Planning Commission Meeting Packet

June 28, 2016

a. Public Hearing – SP 16-04 Sherwood Plaza Apartments

The applicant proposes a six- building, 82-unit apartment complex located behind and east of the Sherwood Plaza commercial development and south of Langer Drive. The property is zoned Retail-Commercial (RC).

11 SITE PLAN
 SHEET: **A1.01**

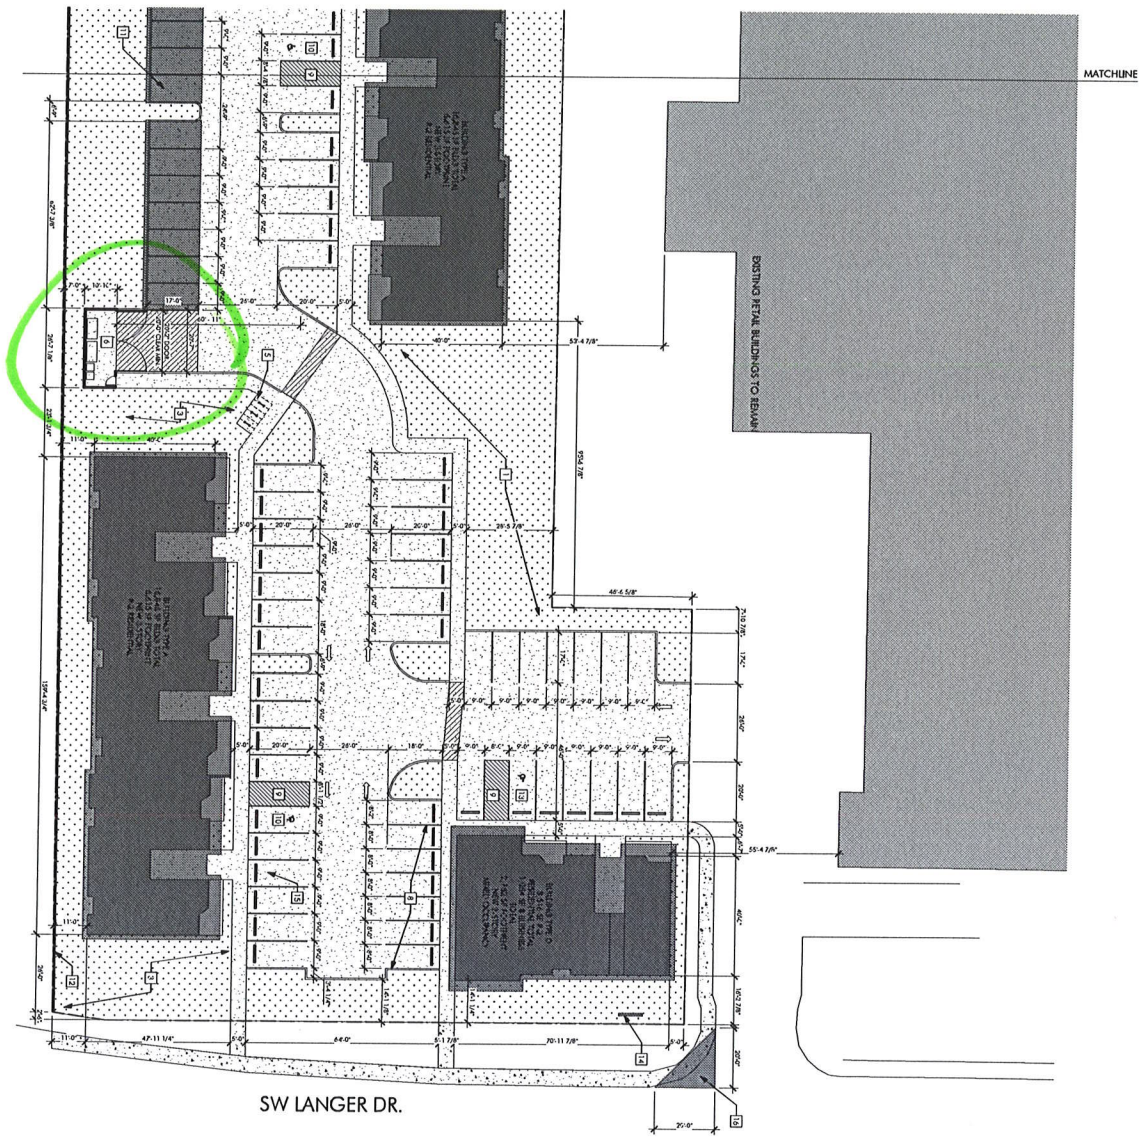
Staff Analysis: As discussed earlier, the northern setback is the front of the site, which requires a 14 foot setback, the southern property line is the rear setback and requires 20 feet and the side yard setbacks are required to meet Chapter 16.68-Infill because the buildings are all over 24 feet in height which will be further discussed below. The applicant’s plans show the front yard setback to be 14 feet and rear yard setback to be 20 feet. (Exhibit A, applicant’s site plan Sheet A1.01 and Sheet A1.02)

Buildings 4 and 5, (sheet A2.03 and A2.05) are both 30 feet tall, 6 feet above the threshold which requires three feet of additional setback or 8 feet. The applicant shows these buildings 11 feet from the side property line. (Sheet A1.01).

Staff Analysis: There is one driveway where the clear vision areas could potentially be affected. The applicant has identified a 20 foot clear vision triangle on Sheet A1.01, showing that there will be no obstructions within the triangle, thus meeting this requirement.

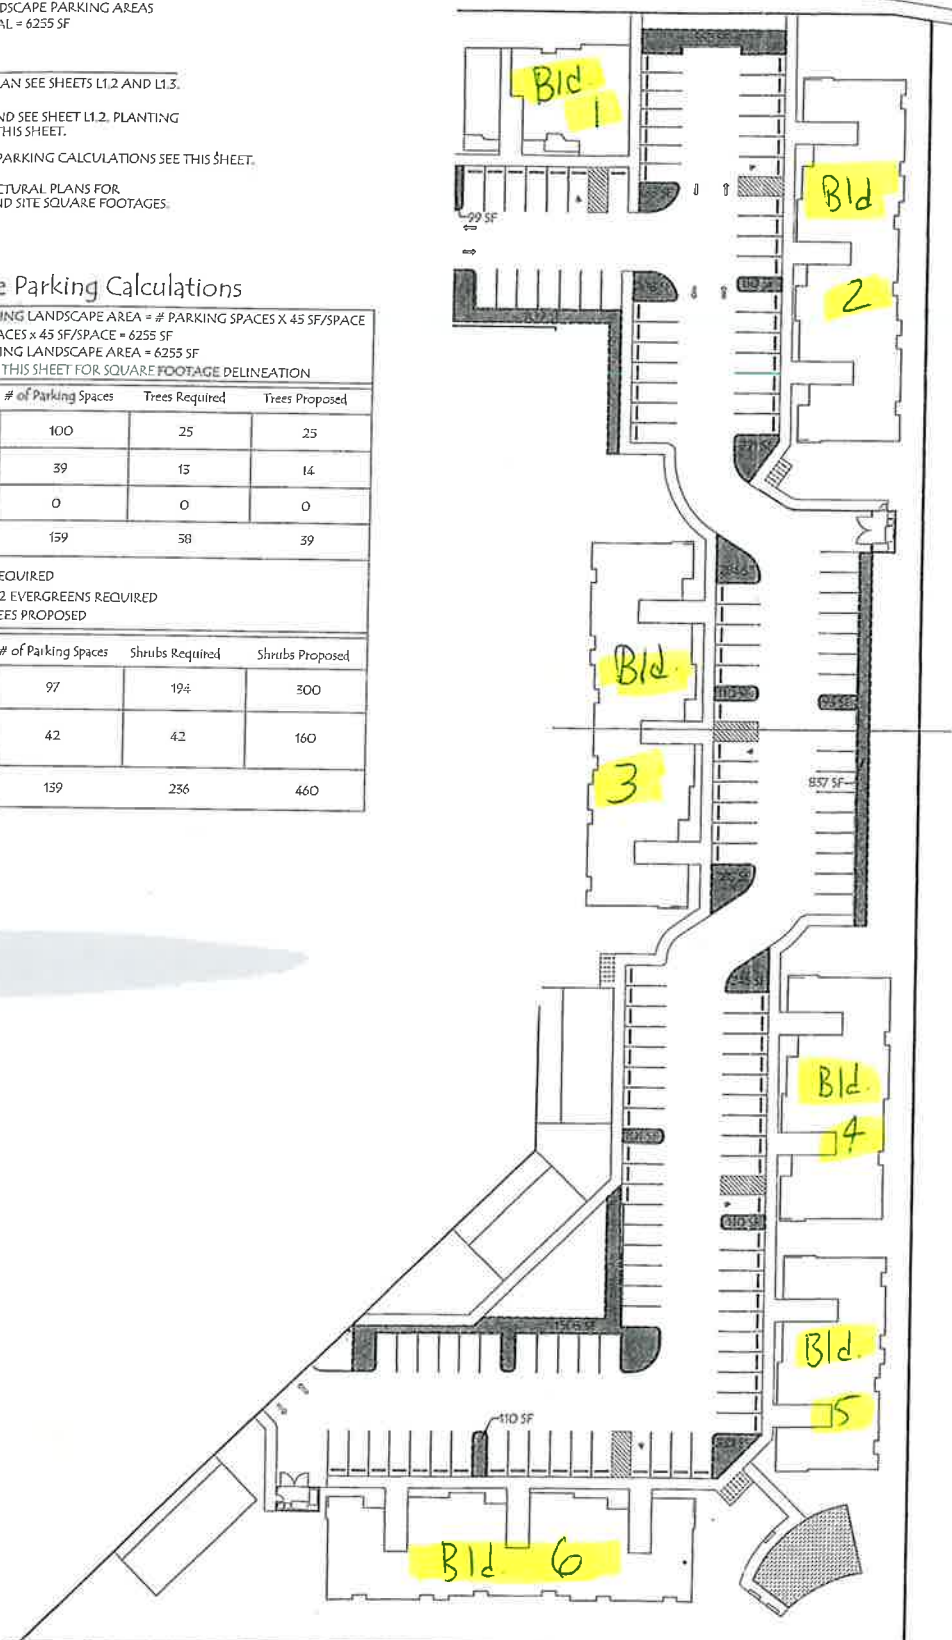
In contrast, the landscape plan, L1.1, shows that 31 trees need to be removed for development. The applicant has not conducted a proper inventory as described in Chapter 16.142, which will be discussed further within this report.

Staff Analysis: The applicant proposes 38 trees onsite to meet the parking area landscaping requirements. The applicant has provided 25 large trees to account for 100 parking spaces and 14 medium trees to account for 42 parking spaces. The applicant has included enough trees per parking space and provided details as to which trees are designated medium or large on the plan set. The applicant proposes two evergreen trees, or 5 % of the required total.

RECOMMENDED CONDITION: Prior to final site plan approval, submit plans that indicate the correct number of trees to be removed or retained, the condition of the trees and if necessary, the reason for their removal.

Exhibit D: Proposed location of pedestrian pathway

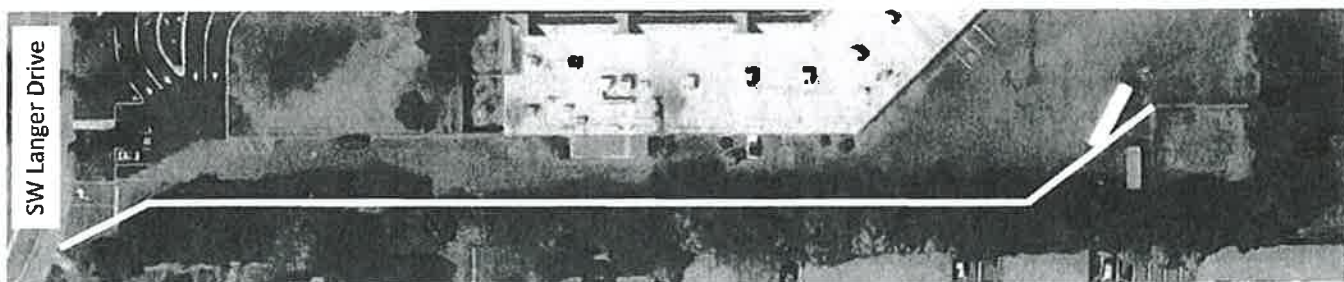
Staff Analysis: The applicant proposes a six foot cedar fence along the eastern boundary and most of the southern boundary, both of which are adjacent to existing residential developments. At the southwest corner of the site, there are existing mature Photinia shrubs that provide screening between developments.

RECOMMENDED CONDITION: Prior to final site plan approval, provide at least one break in the fencing with a five foot wide public pedestrian pathway and a corresponding public non-vehicular access easement centrally located at the eastern boundary to allow adjoining pedestrian access through the site.

Street Facing Elevation of Building 1

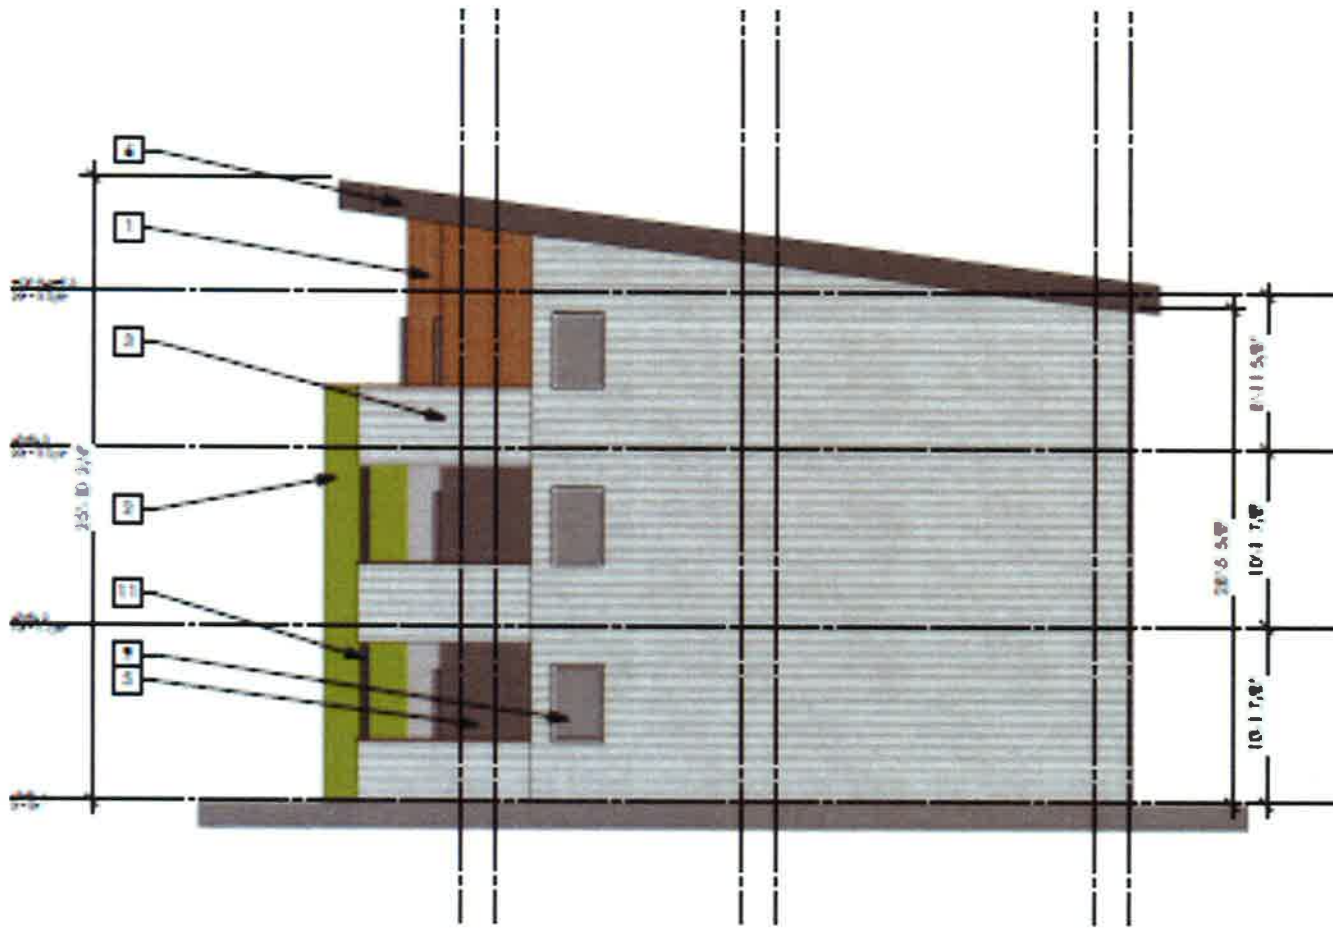
The other building using the front yard setback of SW Langer Drive to the north, "Building A" has a side elevation that directly faces northern SW Langer Drive, with a 28 foot setback. Building 1 and 2 are flush with SW Langer Drive on the north and need to be oriented to the street. The applicant shows a side elevation at this location rather than a front elevation for Building 2, with limited articulation and orientation to the pedestrian. The applicant will need to revise this elevation in order to meet the intention of this standard.

RECOMMENDED CONDITION: Prior to final site plan approval, provide revised elevations for the northern sides of Buildings 1 and 2 which front SW Langer Drive. The elevations shall clearly demonstrate how the buildings are located and oriented to the street, and have significant articulation and treatment, via facades, sidewalk connection, porticos, arcades, porches, portal, forecourt, or stoop to identify the entrance for pedestrians.
